**SANTA CRUZ COUNTY
GROUP**

Re: Santa Cruz Wharf Master Plan Recirculated Draft Environmental Impact Report (DEIR)

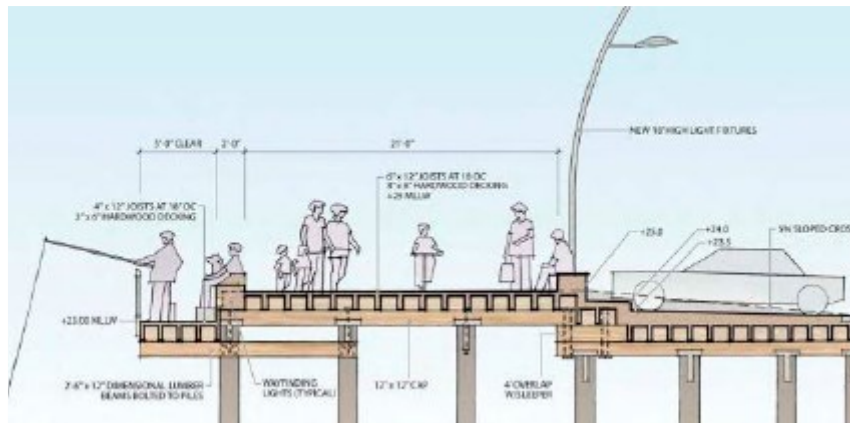
The Sierra Club appreciates and applauds the proposed design for its large bicycle and pedestrian walkway, as seen here:

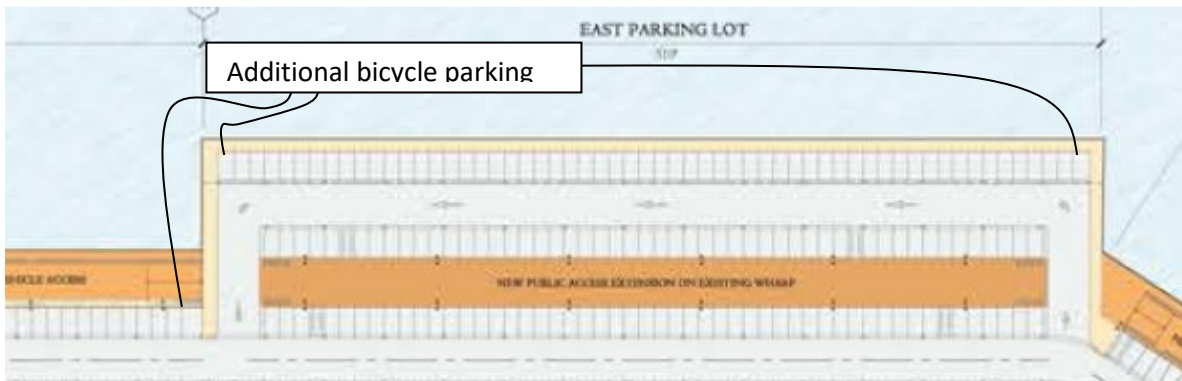
This can give the impression that the Plan takes bicycle transportation seriously. Access is only a portion of visiting the Wharf by bicycle. The design fails to provide adequate bicycle parking. City of Santa Cruz Ordinance No. 2017-02 requires that public or commercial recreation uses have a number of parking spaces of at least 35% of the auto parking spaces. The design calls for 64 bicycle parking spaces yet 495 auto parking spaces – 12.9%. Although mention is made of providing more spaces in the future, how and where these spaces will be is of concern. Namely, whereas all of the auto parking spaces are designed in and indicated, the future bicycle spaces are not, and then evidently must be taken from areas already identified for pedestrian and bicycle use. A Plan without the full amount of required spaces is in conflict with the City requirements; but even if it were not the proposed 64 spaces indicates that bicycle parking is an afterthought in this Plan. We strongly recommend that all corner areas currently designated for auto parking be instead allocated for bicycle parking, so that proper accommodation of bicycles may be achieved:

How does this limited bicycle parking proposed, in conflict with City code, meet transportation requirements, including related to but not limited to greenhouse gas emissions, alternative transportation, and equity access?
